ADDENDUM NO. 2

Snyderville Basin Water Reclamation District
ECWRF Training/Fleet Facility and Seismic Upgrades Project

March 5, 2014

B LOWER PLAN
SCALE: 1/8" = 1'-0"
FILE: 4650E10_TF-S-102

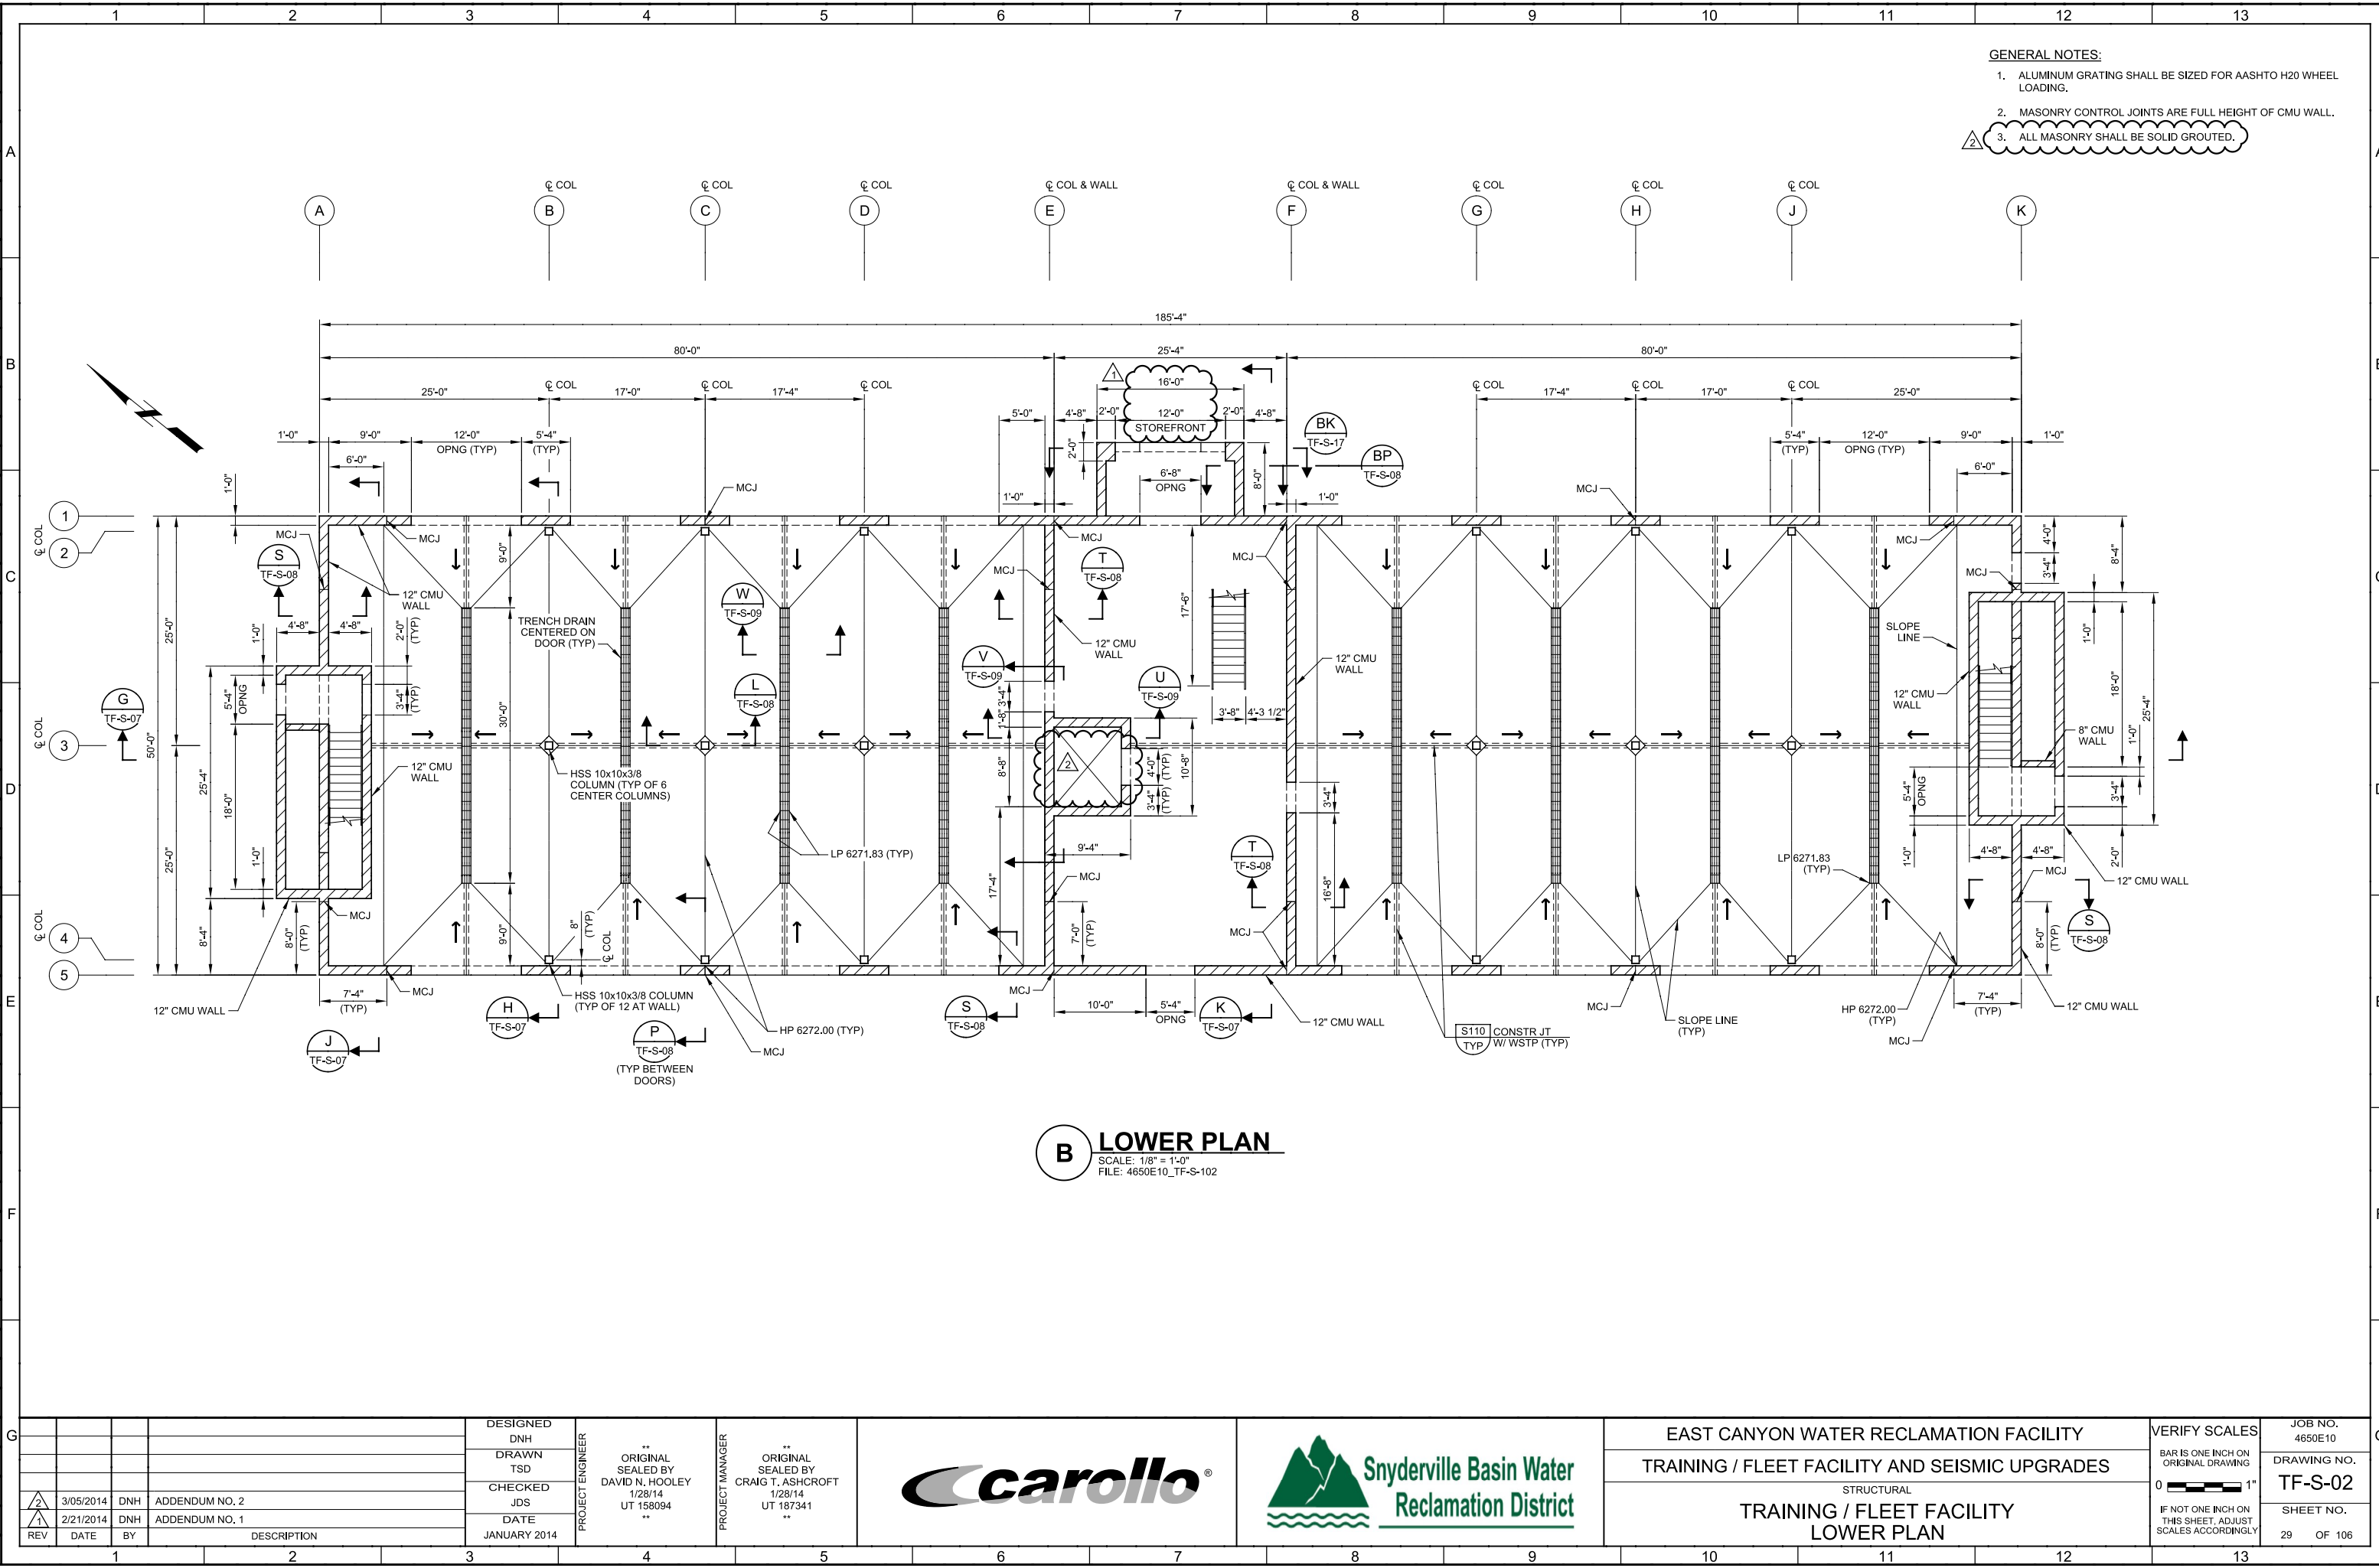
2. Detail A, Lower Plan: Remove the elevator rear door opening in the masonry block wall (door opening into Vehicle Storage Room #101). See the changes to TF-S-02 for more information.

A406

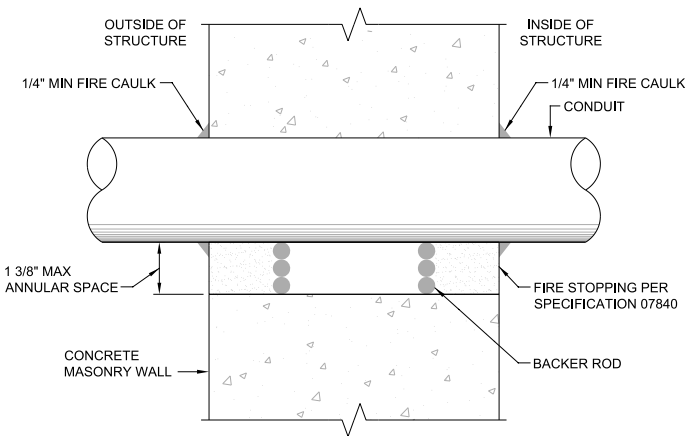
- R. Drawing EG-E-01, sheet 87 of 106.
 - 1. Replace the drawing with the attached drawing EG-E-01.
- S. Drawing TA-03, sheet 91 of 106.
 - 1. Add the attached Typical Detail A406 to this sheet.
